# T10/1826-D

Revision 05  
22 June 2008

## Information technology - SCSI / ATA Translation - 2 (SAT-2)

# Summary of Comments on SCSI / ATA Translation Standard

Figure 2 — ATA document structure

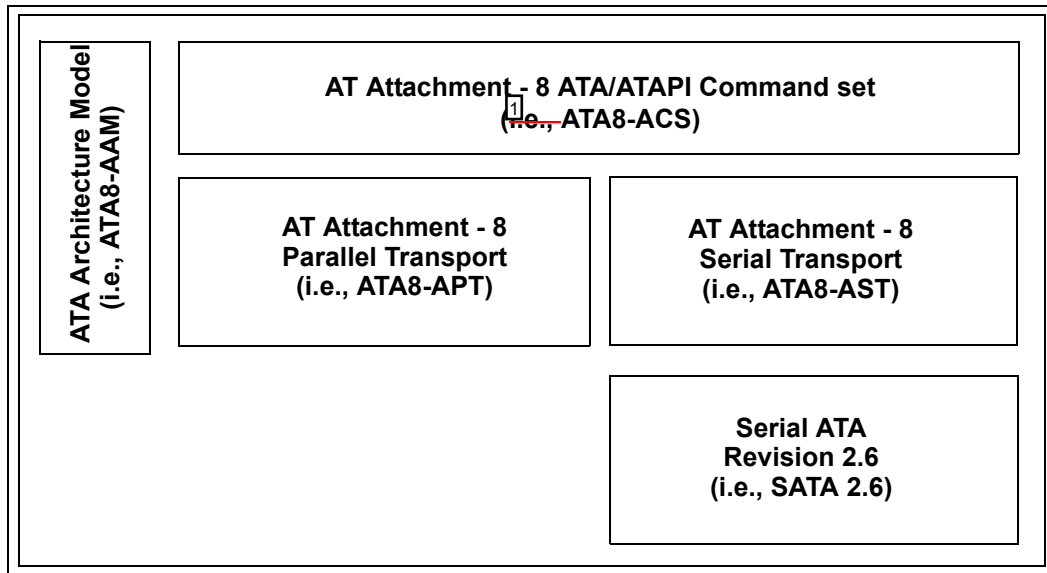
Number: 1 Author: HPQ-RElliott Subject: Cross-Out Date: 9/3/2008 9:42:24 AM -07'00'

Delete all the "i.e."s from figure 2. That is not used for acronyms in parenthesis - just the acronym is fine, like "(ATA8-ACS)"

moverby Accepted 9/11/2008 11:33:18 AM -07'00'

Figure 3 — SCSI / ATA Translation document role

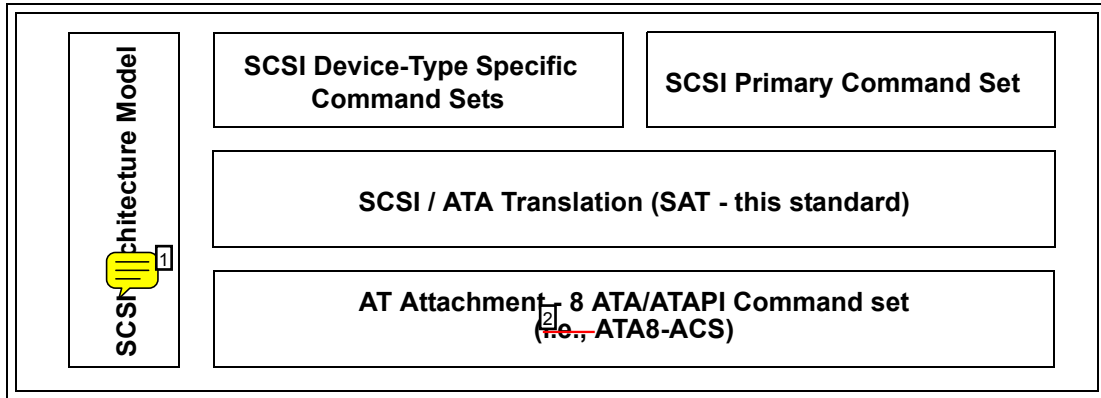
Number: 2 Author: HPQ-RElliott Subject: Cross-Out Date: 9/3/2008 9:42:24 AM -07'00'  
Delete i.e., in figure 3 (see reasoning in comment on figure 2)

**Figure 10 — Translation of Logical Sector Alignment (part 3)**

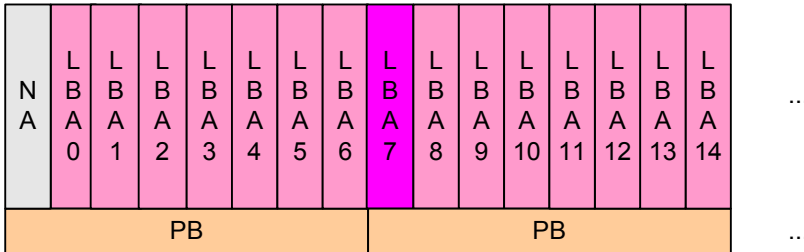
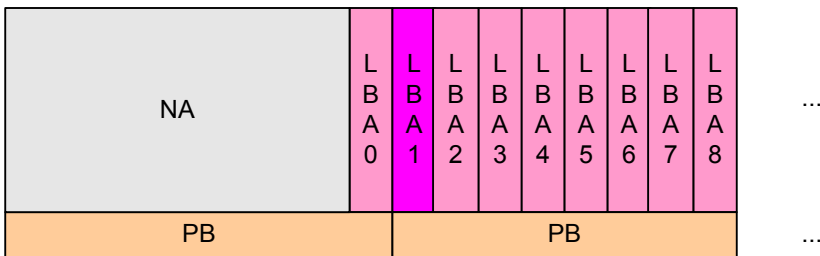
Number: 1 Author: Kevin\_Marks Subject: Highlight Date: 8/11/2008 12:51:30 PM -07'00'  
Figure 10 missing reference in text
